**Strategic Planning Instrument  
Rezoning - Planning Proposal**

Rezone part of the land for low density residential purpose and retain the existing environmental conservation portion of the site.

Planning proposal PP-2022-3016 to amend Lake Macquarie Local Environmental Plan 2014

Property Address:	1377 HUE RD, WYEE NSW 2259
Lot & Plan number:	Lot 437 DP 755242
Development Description:	Preliminary Servicing Application for Torrens Title Subdivision of 1 lot into 60 Lots
Hunter Water Reference:	2023-1565

**Figure 1 – Location of required watermain extension to service proposed development**

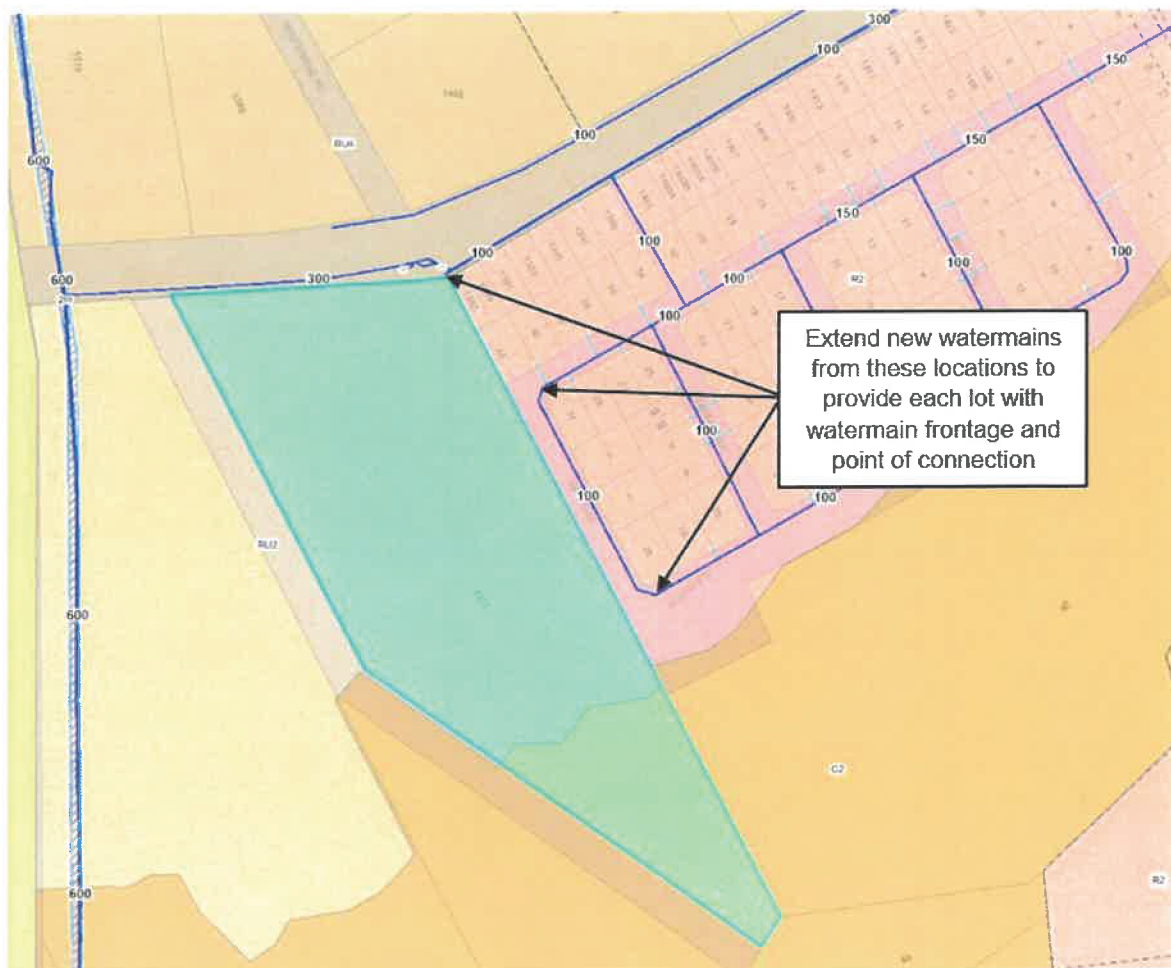
The development site is immediately adjacent to the Radcliffe Wyee residential development and has frontage to an existing DN100 PVC-O watermain on Jarvis Rd (see Figure 1). There is sufficient capacity to service the proposed development, and the developer will be required to extend watermain to provide each lot with a watermain frontage and point of connection.

Proposed lots 1 to 9 are not permitted to connect the existing DN300 DICI watermain on Hue Hue Rd, and the required watermain extensions through the development from Jarvis Road will need to connect to the existing DN100 PVC-O watermain terminating outside 1387 Hue Hue Rd (see Figure 1).

**Figure 3 – Wyee 2 WWPS, 21 Colleen Lane and Wyee West Paper Subdivision**

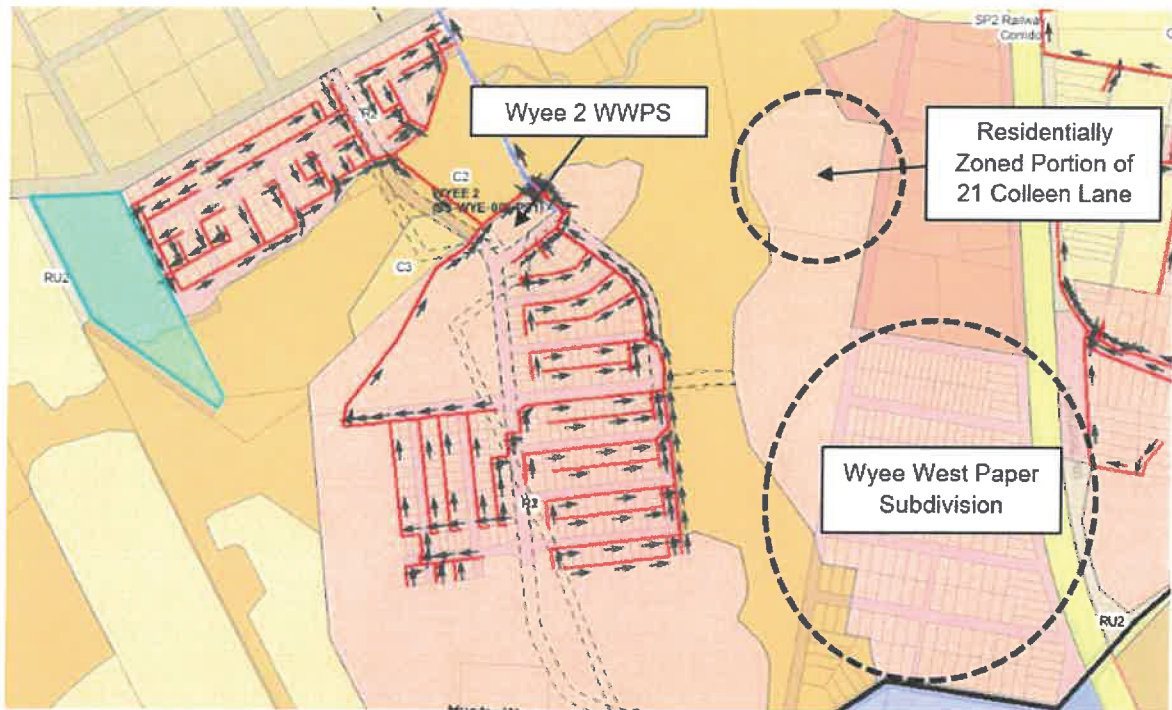
Flows from the proposed development will ultimately drain to the Wyee 2 Wastewater Pump Station (WWPS). The Wyee 2 WWPS was designed and constructed to service the Radcliffe Wyee residential development, the Wyee West paper subdivision and the residentially zoned portion of 21 Colleen Lane (see Figure 3). There will be insufficient capacity in the Wyee 2 WWPS to service all of these developments without upgrading the WWPS.

You will be required to upgrade Wyee 2 WWPS if there is no capacity available when you are ready to connect. The scope of a required upgrade to the Wyee 2 WWPS will need to be determined as part of a Complex Works design that will be identified as a requirement in any future application for Development Assessment (Section 50).
